Bid Bulletin #02

PROJECT: Ogallala Community Hospital Outpatient/Infusion Clinic Expansion

DATE: June 6, 2013

Addendum 2

PROJECT NO. 12188	DATE 06/04/2013	DRAWING REF.	MES101	SKETCH ESK-001
		TYPE	Addendum #2

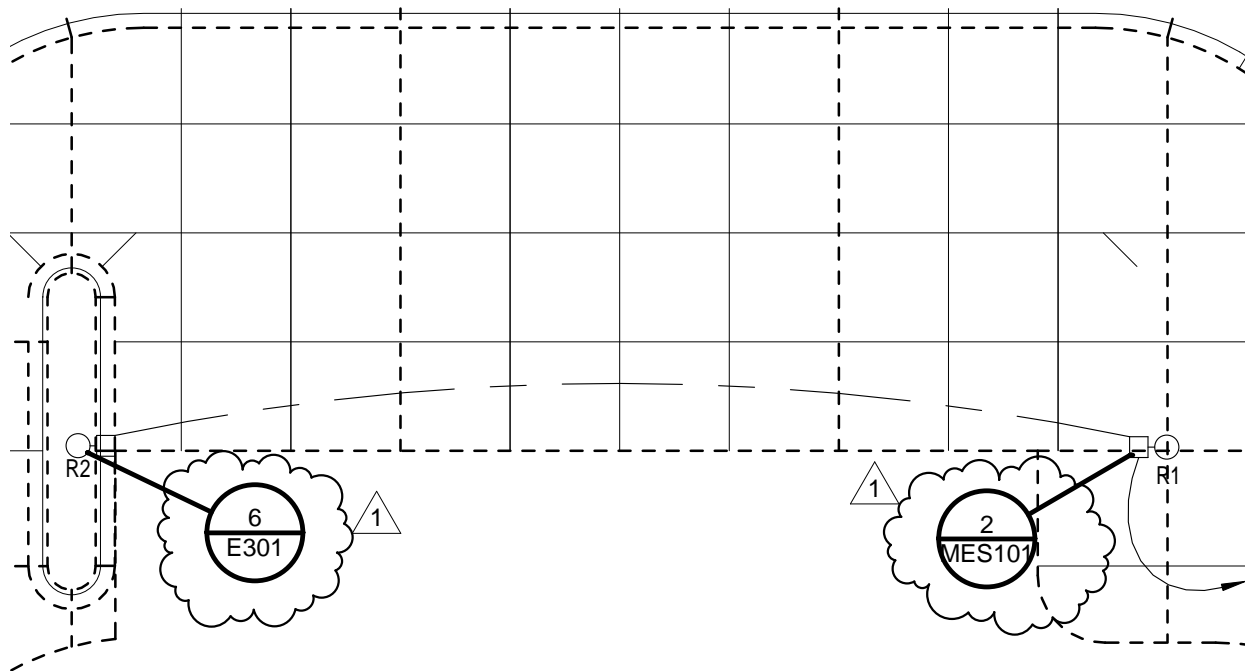
ED1. Sheet MES 101 – Site Plan – Mechanical & Electrical Plan

- A. Provide revised pole base for indicated pole per Sketch Sheets ESK-001 and ESK-002.

A021

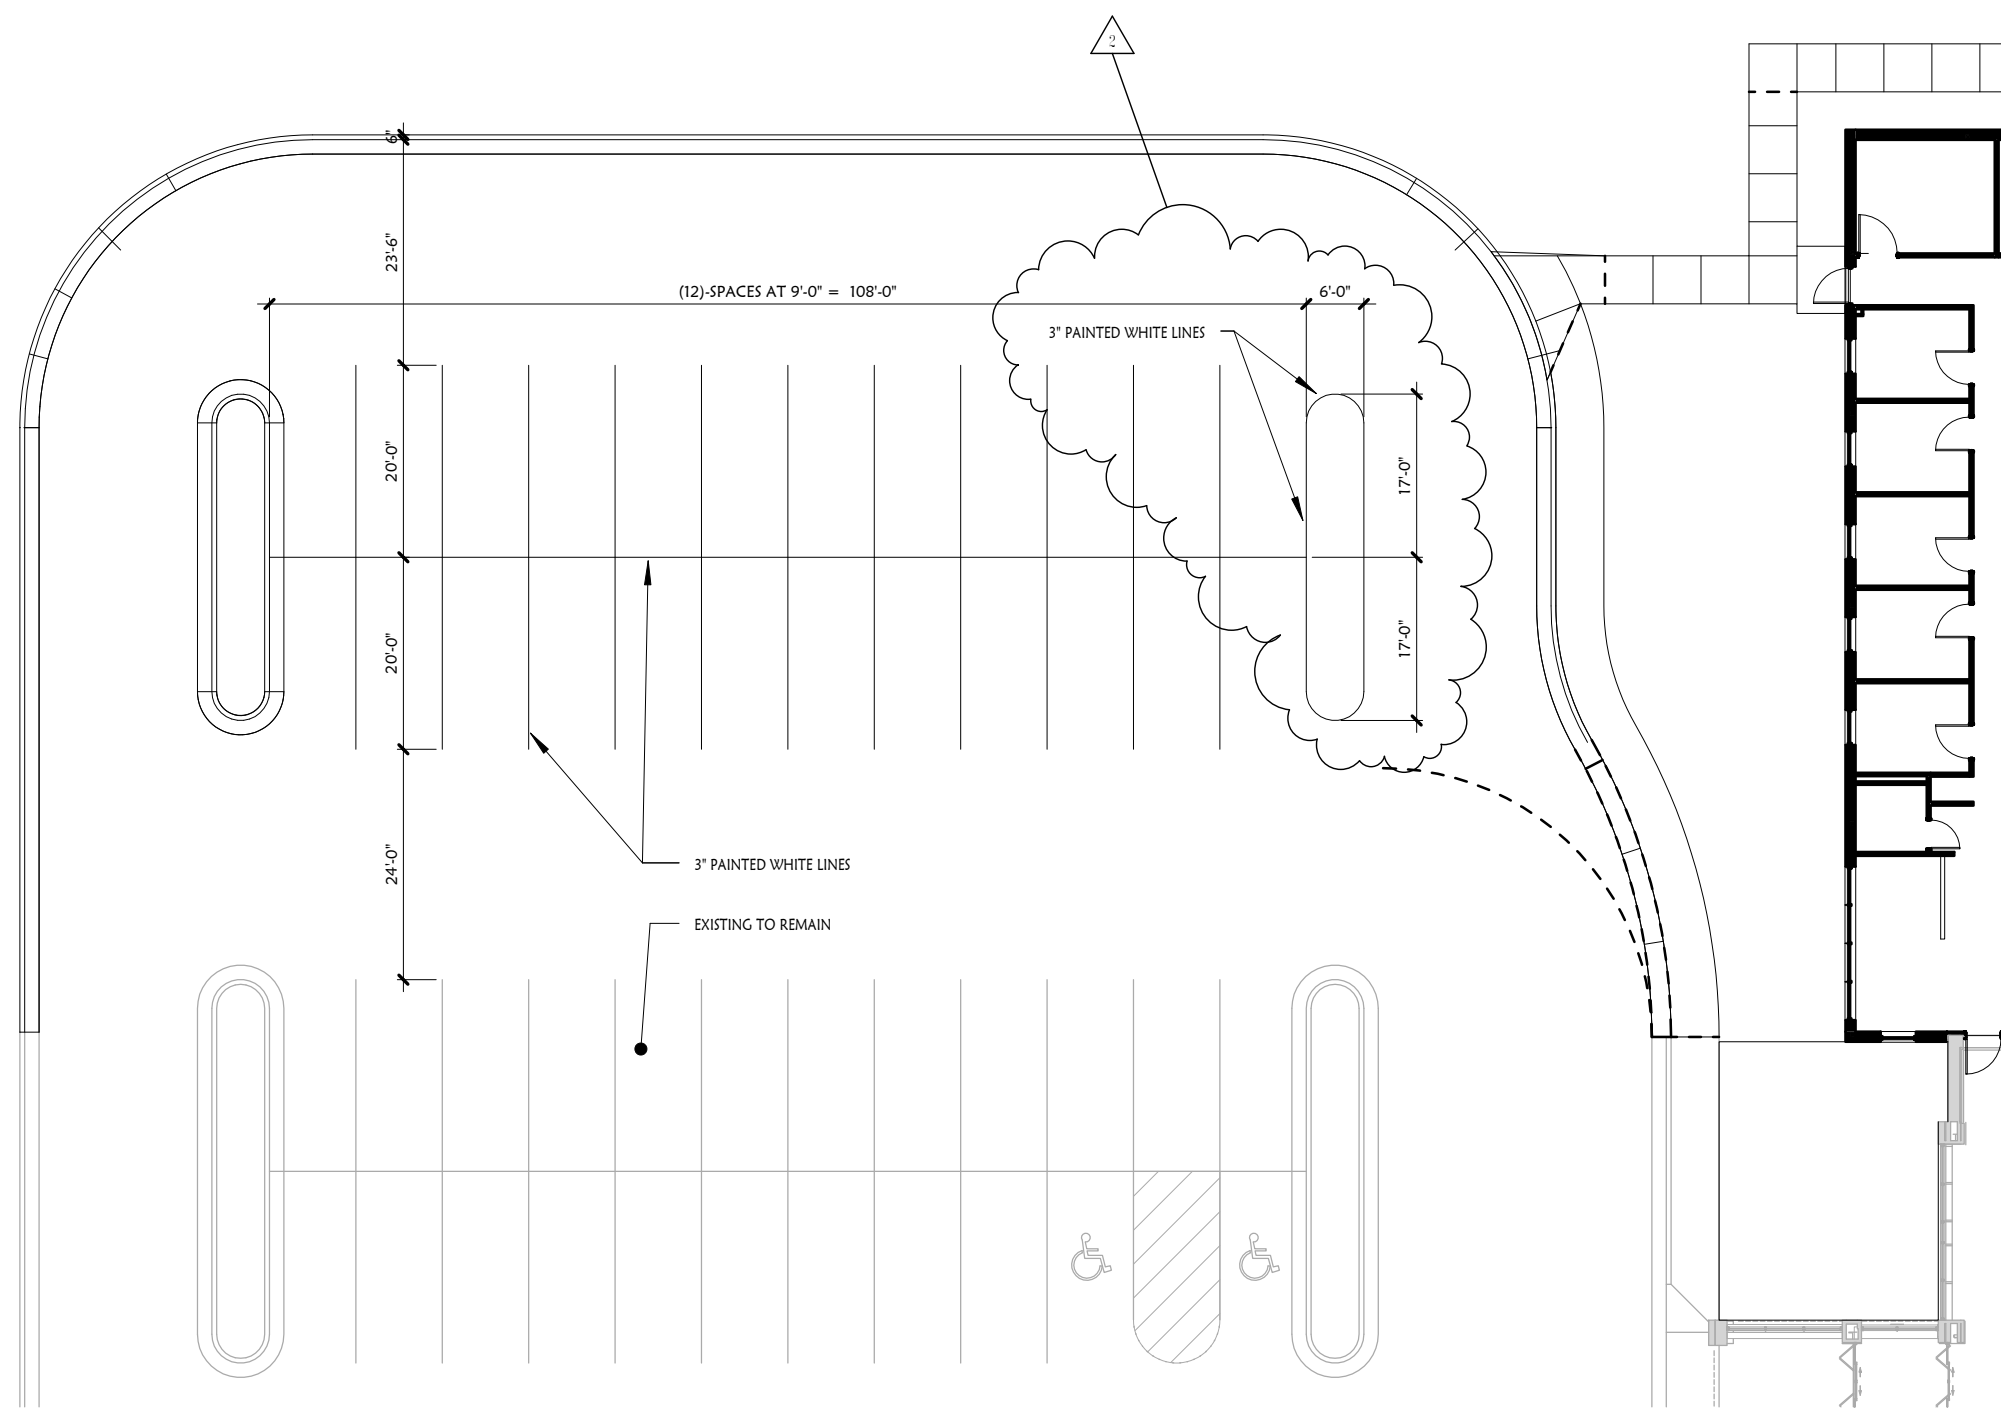
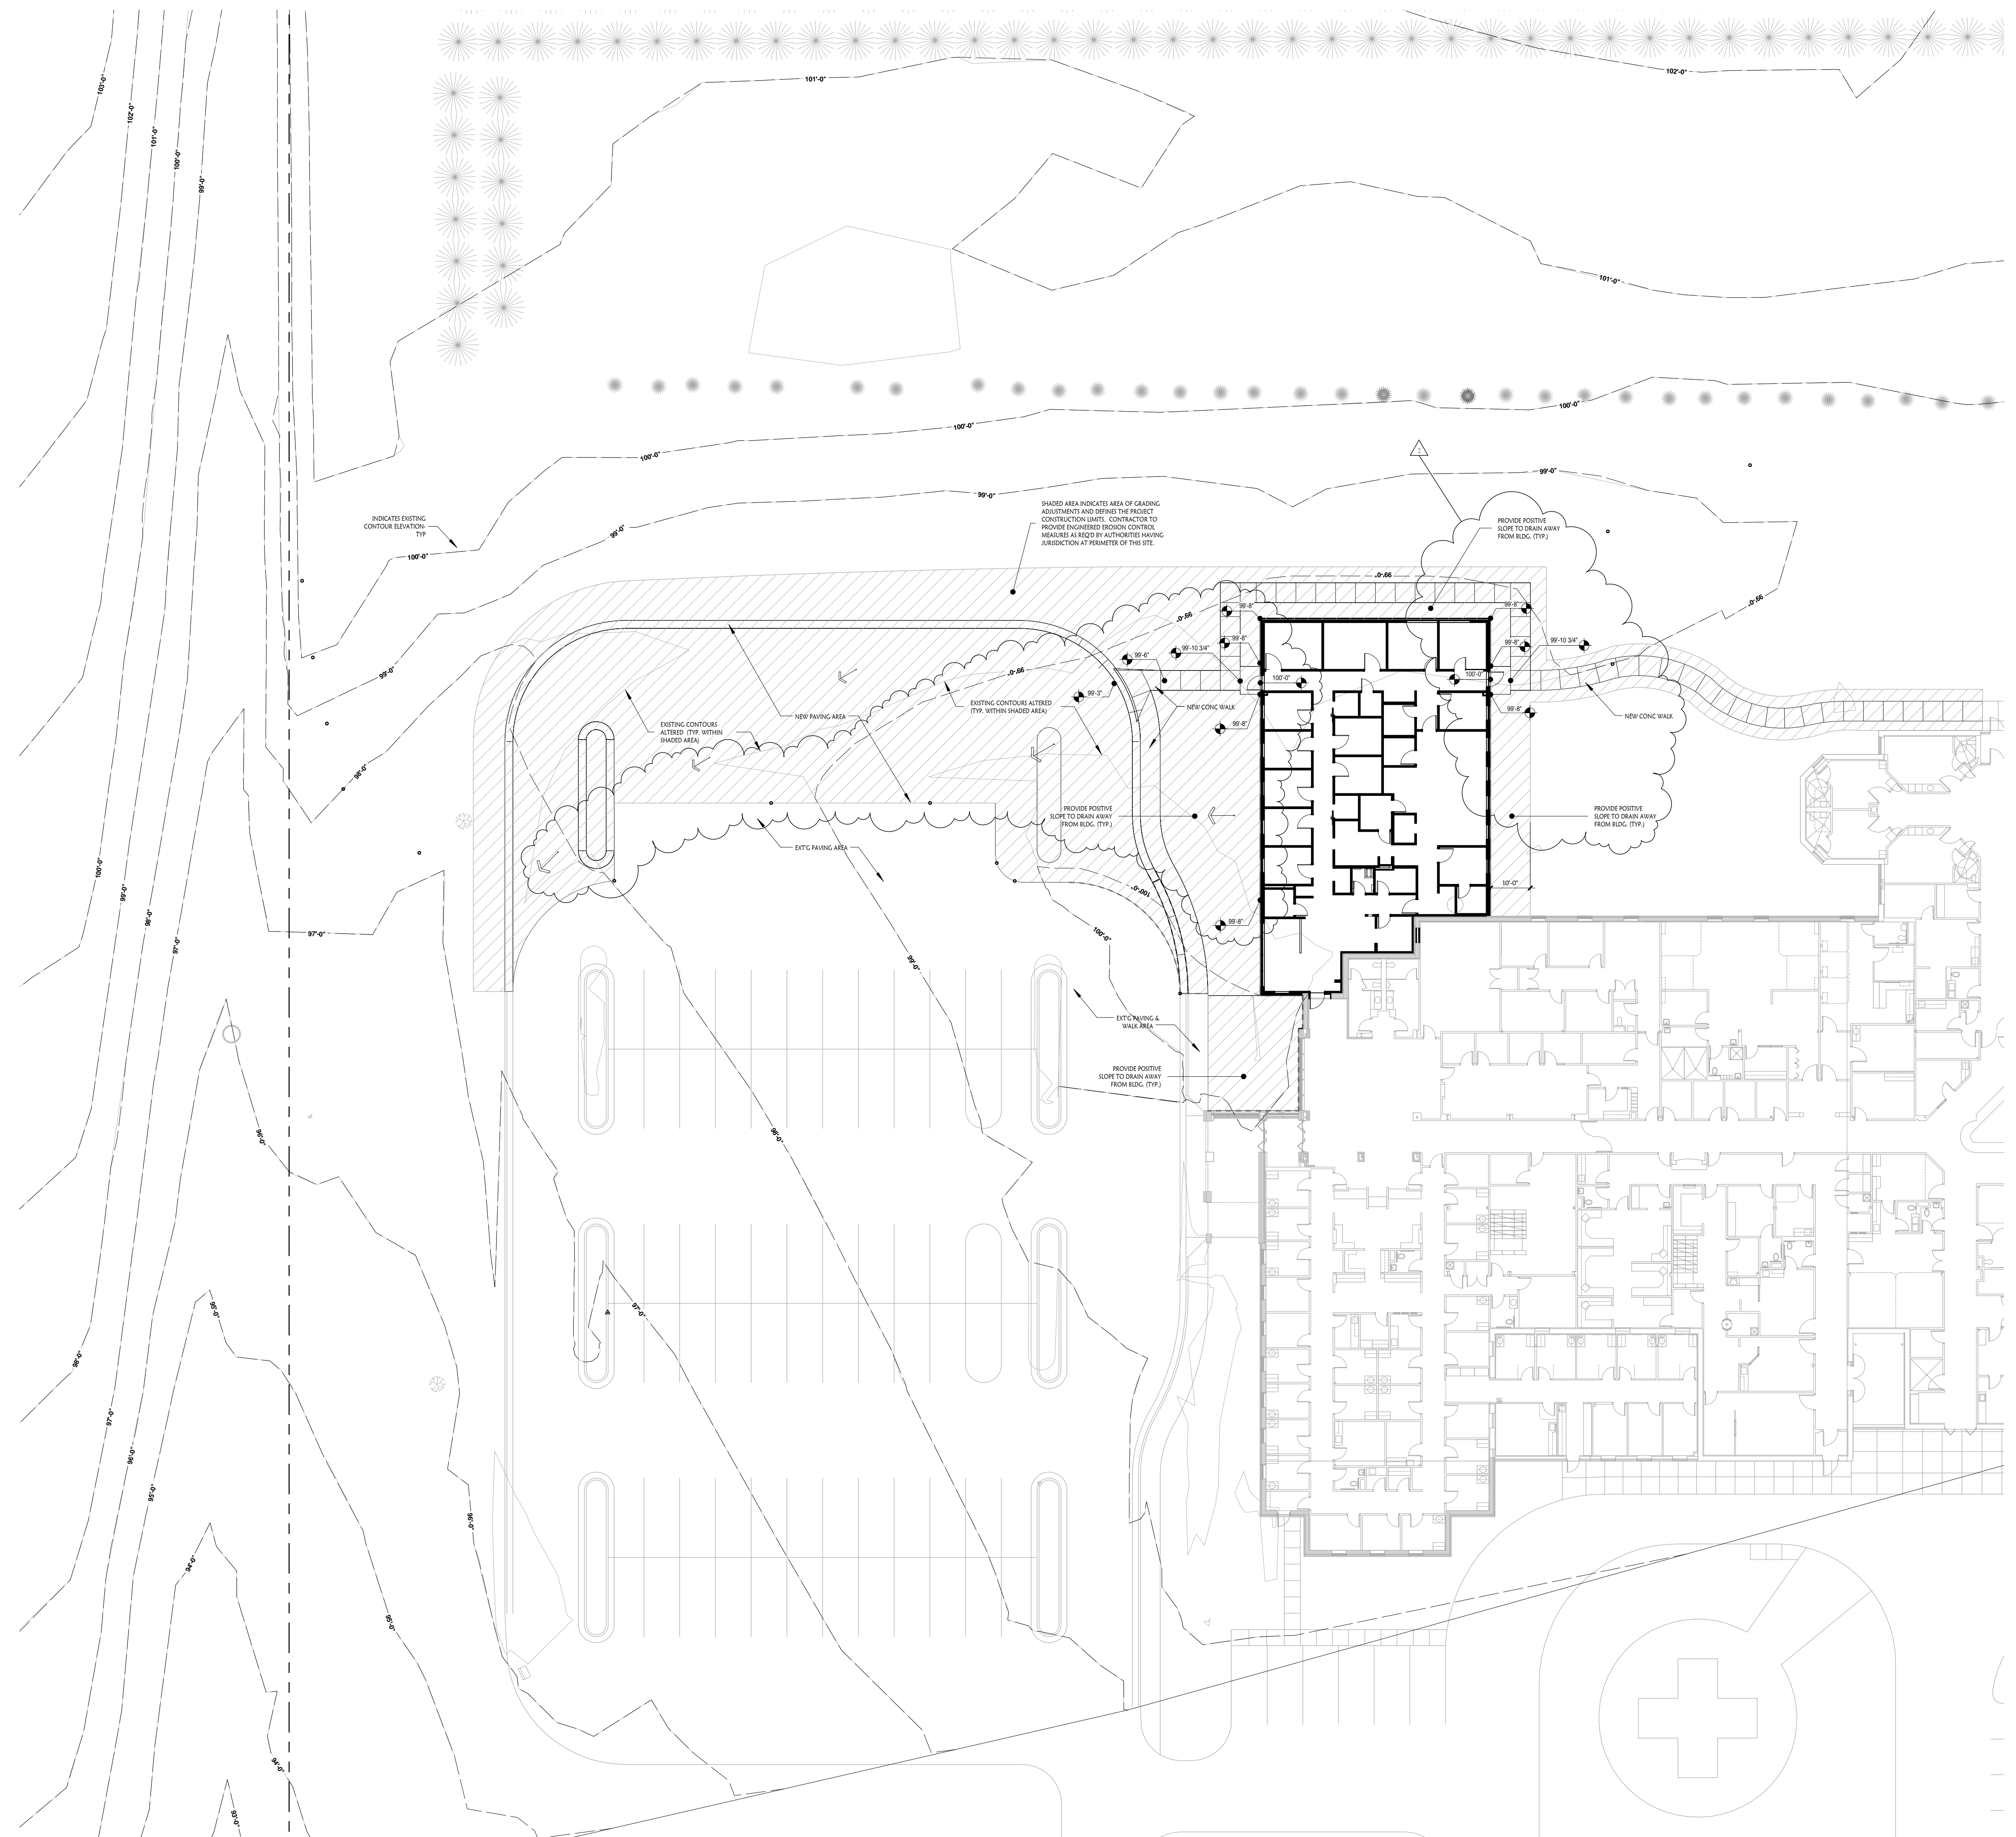
Item 2-4 Attached is revised sheet A021 - alter striping plan to omitted island and alter grading plan with notes to indicate positive drainage away from the building and adjust contour 99'0" at the northwest side of the addition.
